Project Number: SP2018-025
Project Name: Office Building
Project Type: SITE PLAN
Applicant Name: PSA ENGINEERING, LLC
Owner Name: ROCKWAY, PARTNERS LLP
Project Description:

RE: SITE PLAN (SP2018-025), Office Building

Project Number SP2018-025	Owner ROCKWAY, PARTNERS LLP	Applied 7/17/2018 LM
Project Name Office Building	Applicant PSA ENGINEERING, LLC	Approved
Type SITE PLAN		Closed
Subtype		Expired
Status P&Z HEARING		Status 7/24/2018 DG

SHEET: A2.0

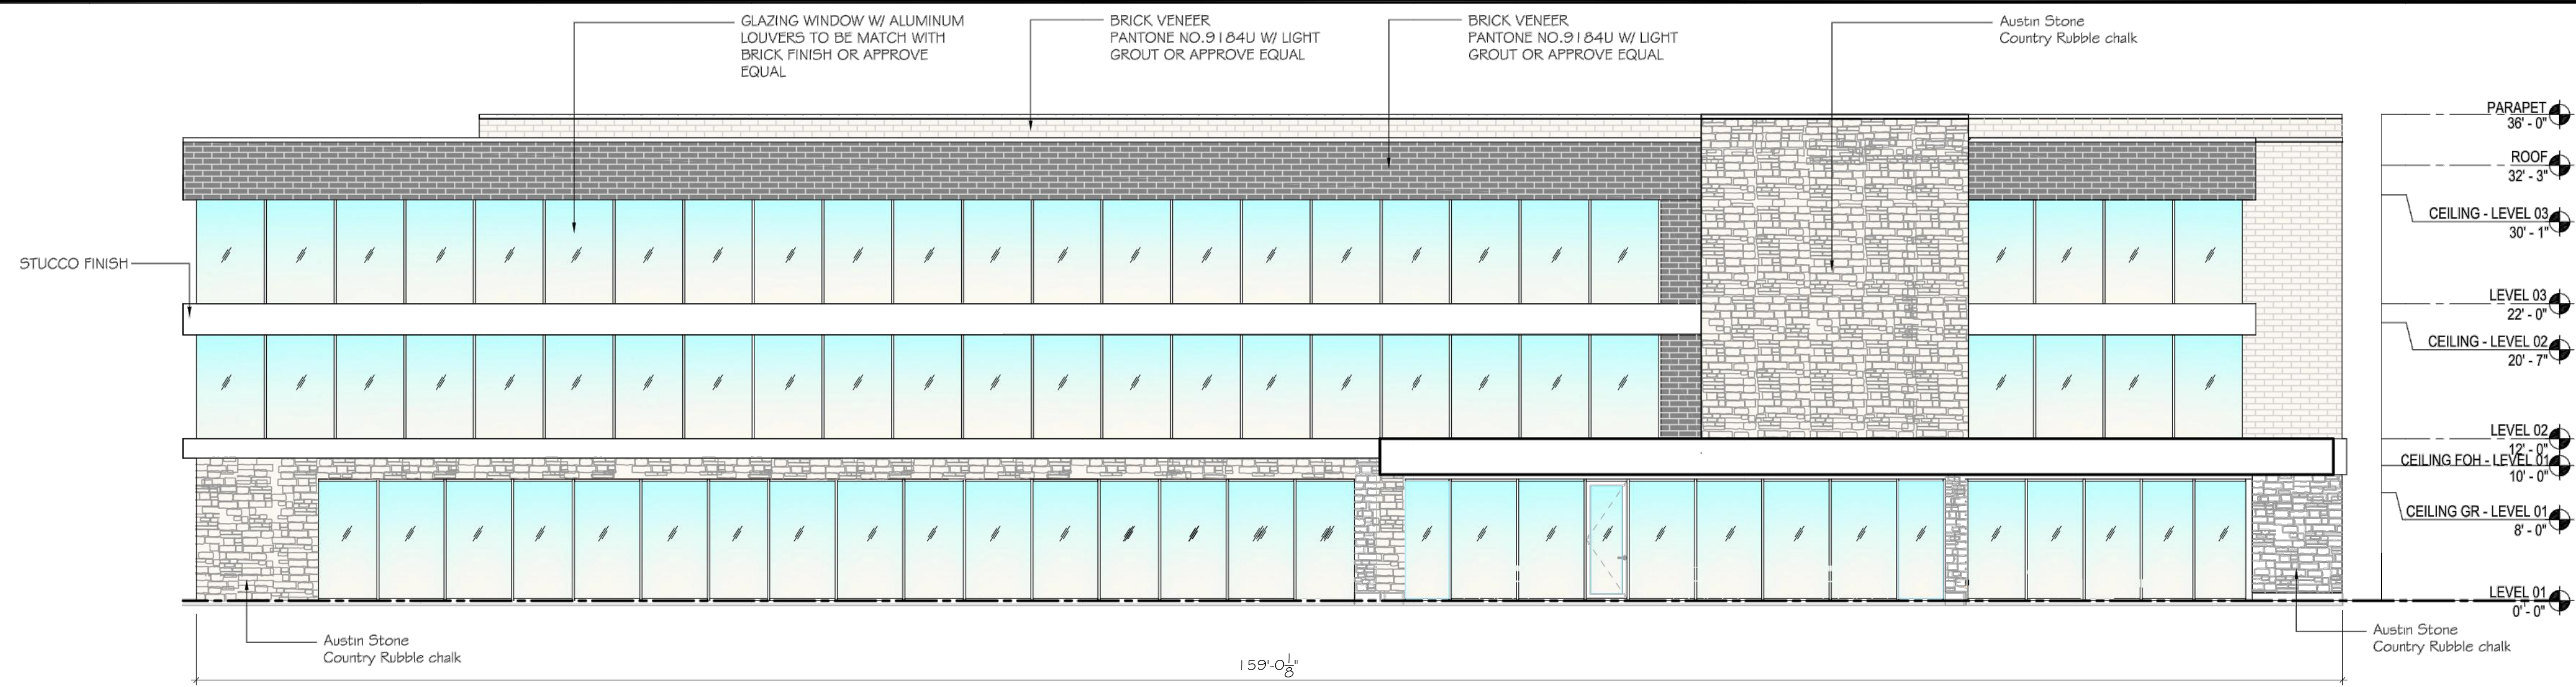
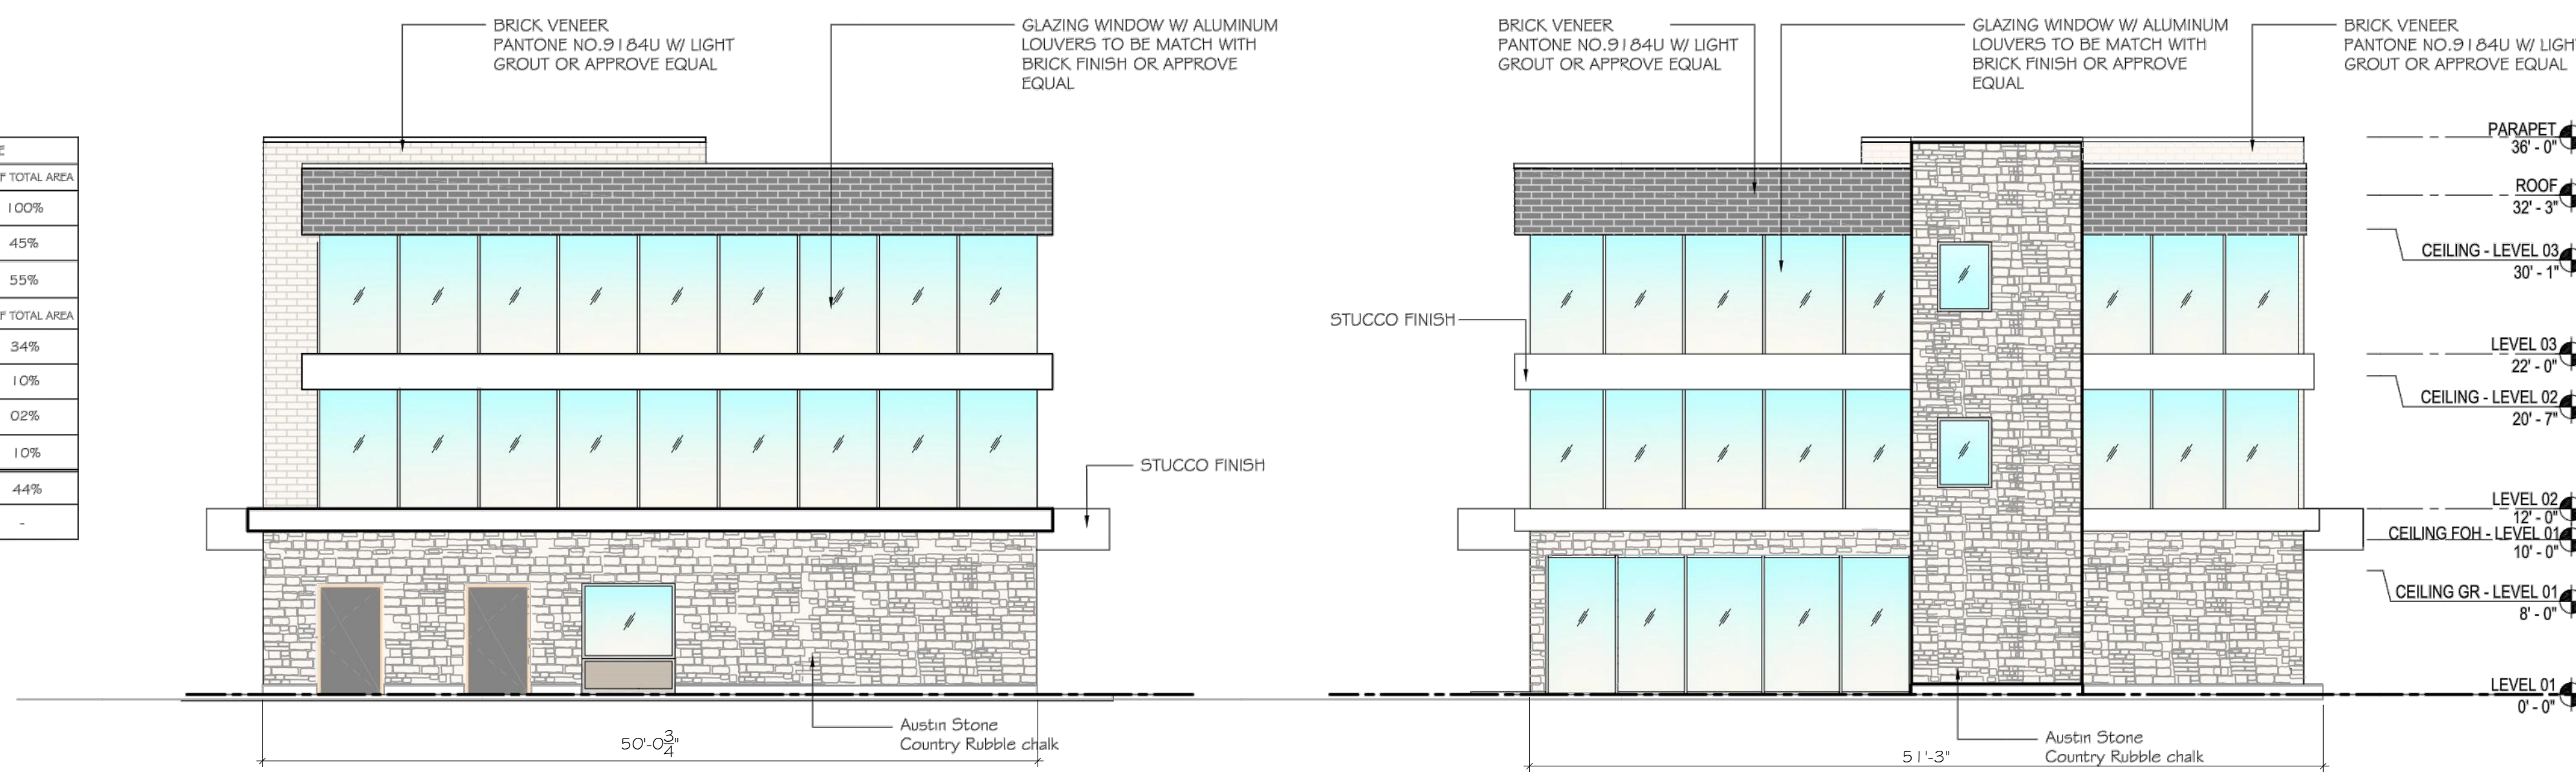
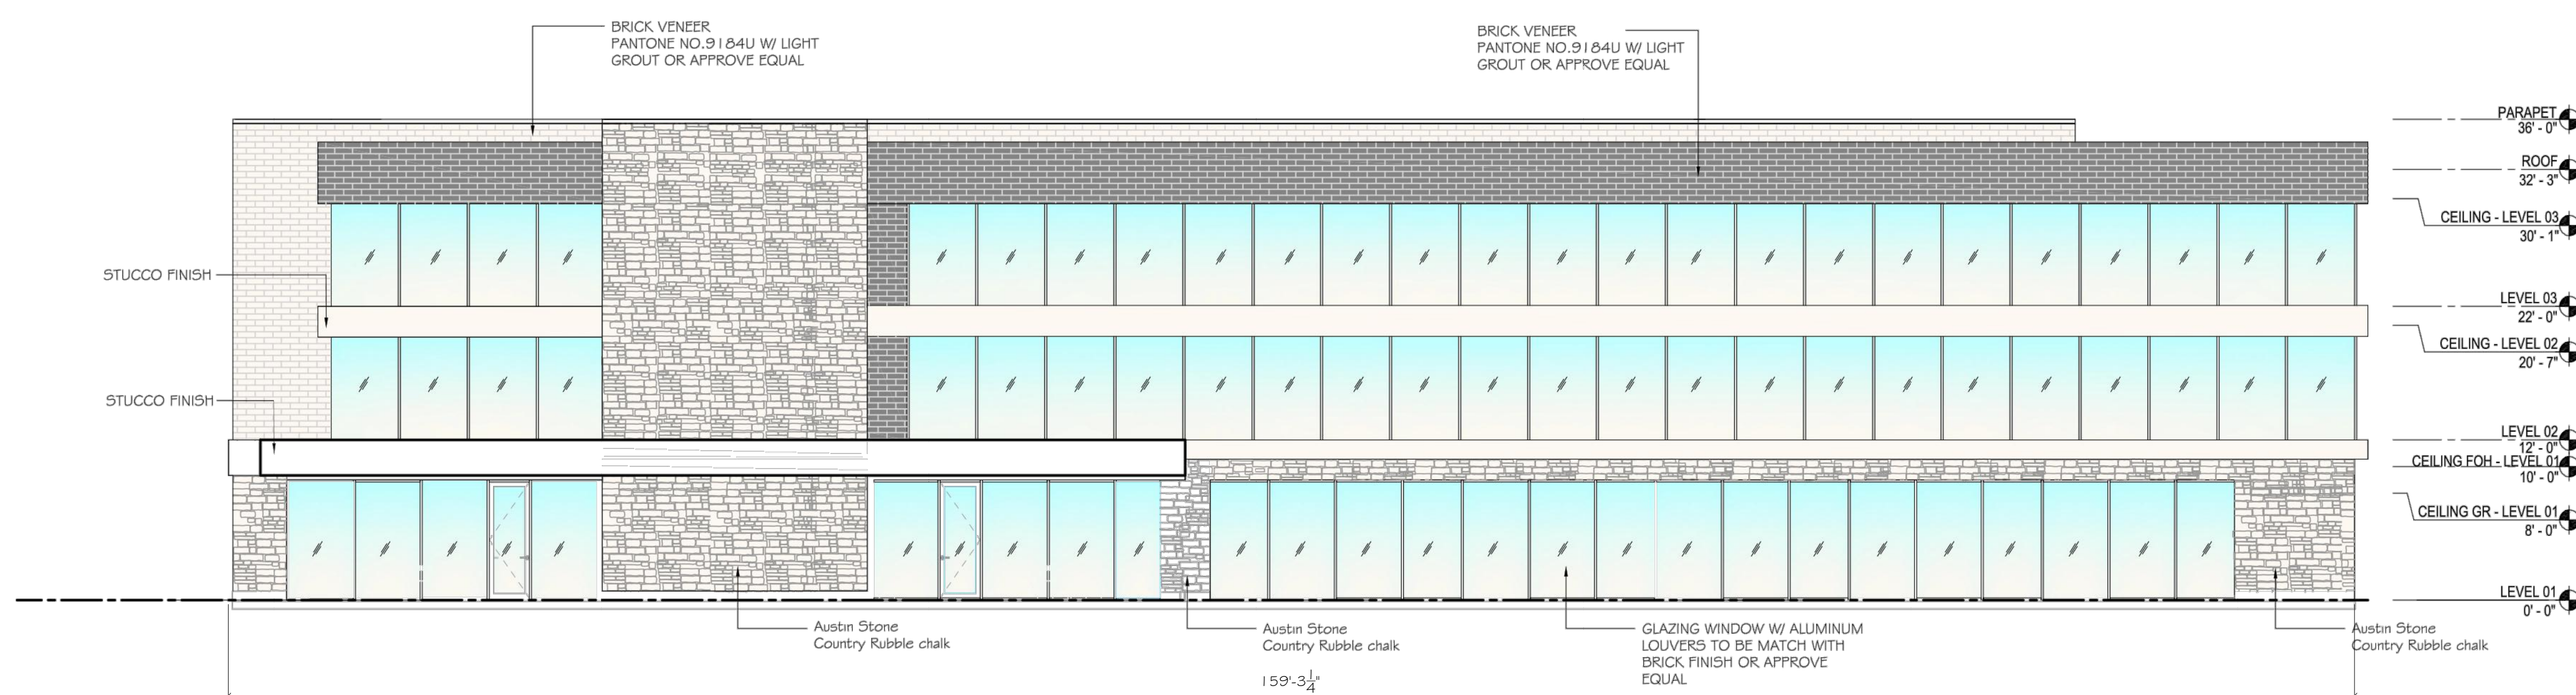
1. Requires a recommendation from the Architectural Review Board (ARB) forwarded to the Planning and Zoning Commission for consideration.
2. Length of building does not equal building footprint on site plan. Verify and correct.
3. Dash in RTU's. Must be visually screened from rights-of-way and adjacent properties.
4. See variance above for not meeting the vertical articulation standards.
5. See variance above for not meeting the minimum 20% stone requirement.
6. Provide a materials sample board for the ARB meeting on July 31, 2018.

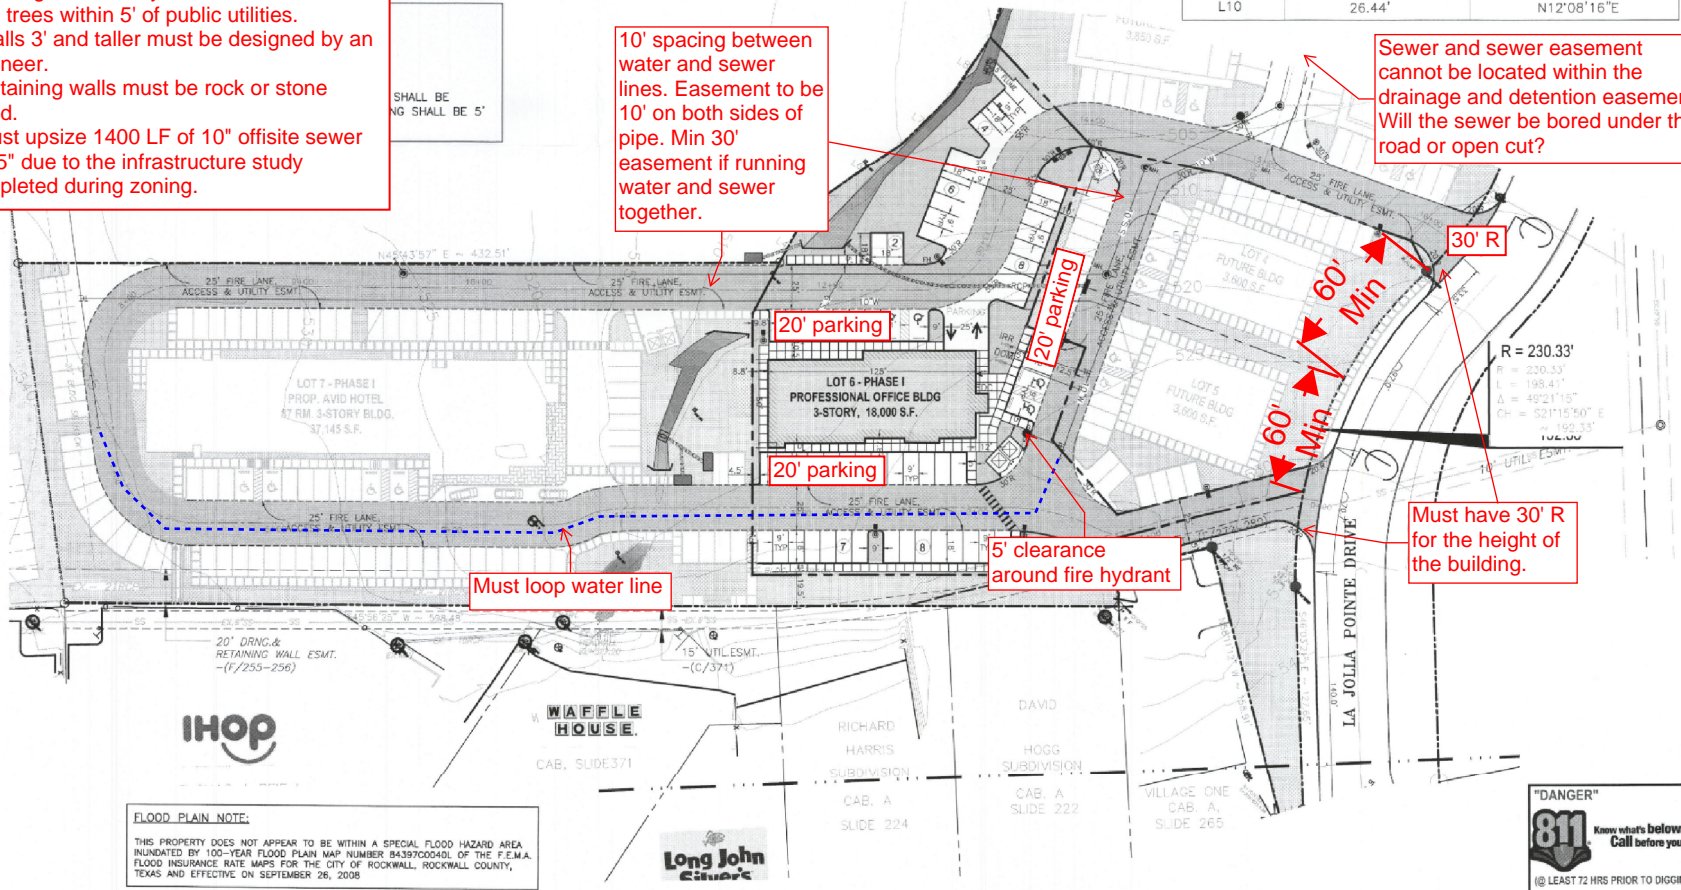
- Impact Fees must be paid.
- 4% Engineering Inspection fees
- Must meet all Engineering Standards of Design
- All storm outfalls of flow downstream not at a 90° angle.
- Must build complete water line loop now.
- must check existing detention to make sure the approved volume and outfall is still correct.
- Need to establish the 100-yr water surface elevation in open channel area.
- Parking to be 20' by 9' standard.
- No trees within 5' of public utilities.
- Walls 3' and taller must be designed by an engineer.
- Retaining walls must be rock or stone faced.
- Must upsize 1400 LF of 10" offsite sewer to 15" due to the infrastructure study completed during zoning.

10' spacing between water and sewer lines. Easement to be 10' on both sides of pipe. Min 30' easement if running water and sewer together.

Sewer and sewer easement cannot be located within the drainage and detention easement. Will the sewer be bored under the road or open cut?
